# AST-L IS NOW MORE COMPACT

Better fit on low bed trucks!

Changes effective Spring, 2020.

## 3. ARM LENGTH REDUCED (3")

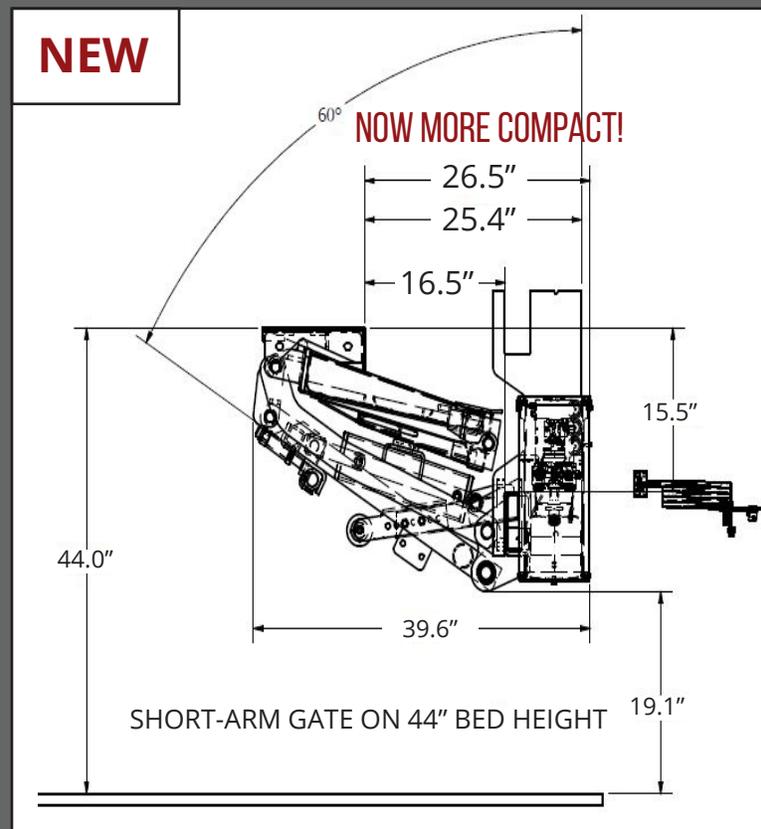
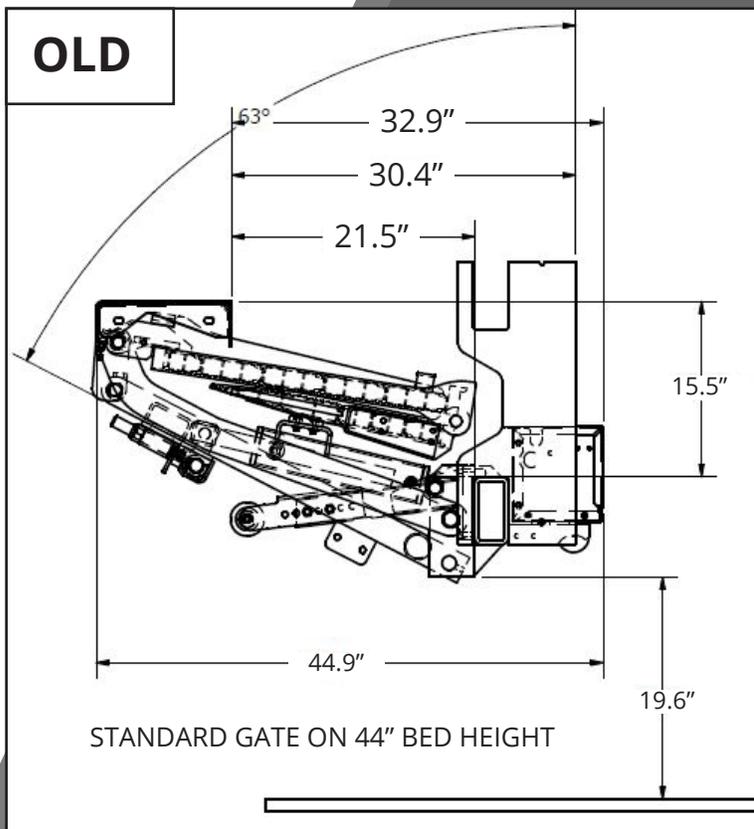
- Requires up to 5" less clearance forward of body rear edge
- No change in bed height range
